Groundwater Application Review Summary Form

Application # G- 19365

GW Reviewer Phillip I. Marcy Date Review Completed: 10/09/2023

Water-Level Measurements in Nearby Wells

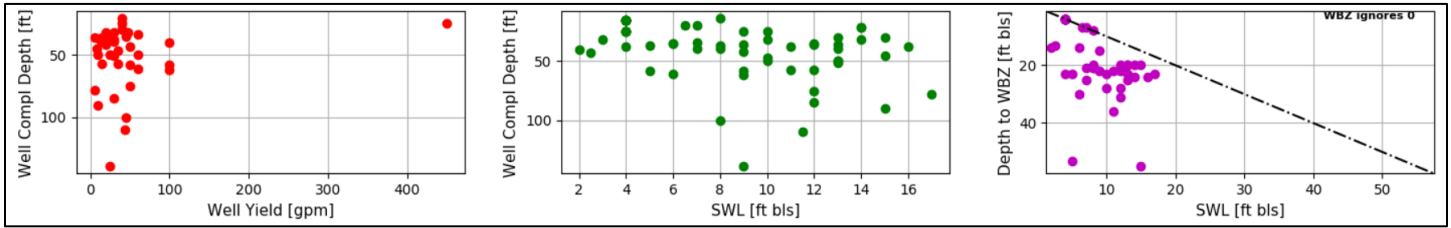
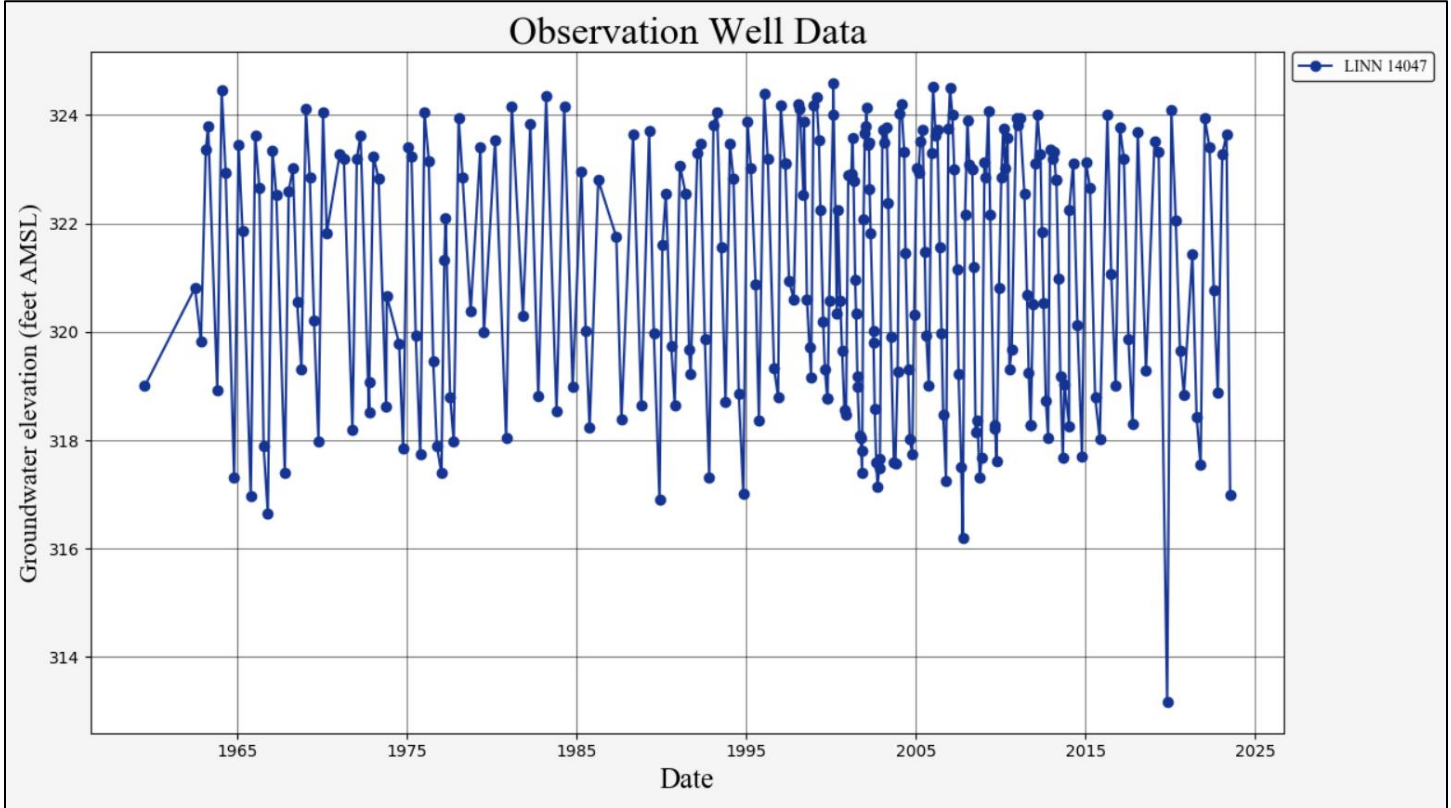
B3. **Groundwater availability remarks:** The only nearby observation well with a significant length of record is LINN 14047, located 2.5 miles SSE from the proposed development. Available data display seasonal variation of 5-6 feet but do not suggest any long-term declines in groundwater elevation in the area.

Stream Depletion (Hunt) Model Analysis

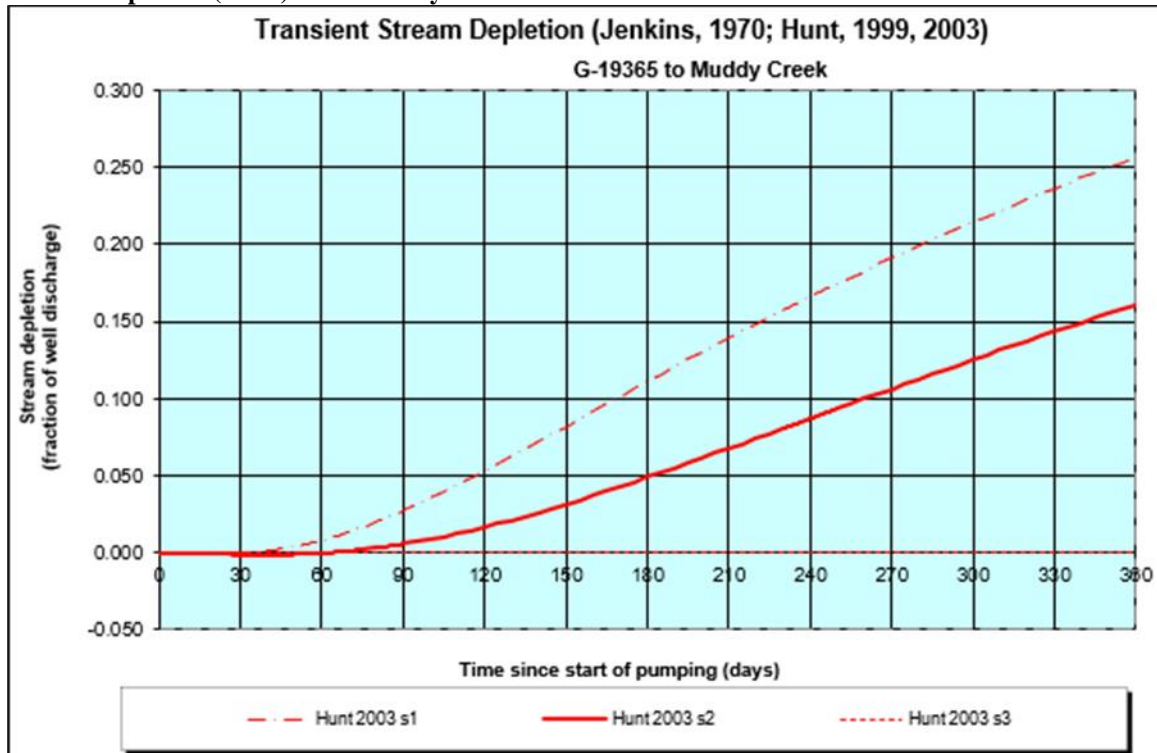
The nearest senior groundwater POA is greater than 1.5 miles from either of the proposed POA locations and given the low diffusivity (high storativity and medium conductivity) of the aquifer here, taken with the relatively low pumping rate, significant interference with nearby groundwater users is not anticipated to result from the proposed use. The proximity to Muddy Creek, which constitutes a constant recharge boundary in our conceptual model, renders stream depletion much more likely than impacts to other wells.

Basis for aquifer hydraulic connection evaluation: Aquifer material to be accessed by the proposed POA wells are incised by the nearby creek, and there are no demonstrated barriers to groundwater migration between the stream and the water-bearing zones in the wells. The presence of fine-grained materials within the stream channel may somewhat inhibit communication between the aquifer and the stream, thus slowing the response to pumping, but these do not prevent stream depletion outright.
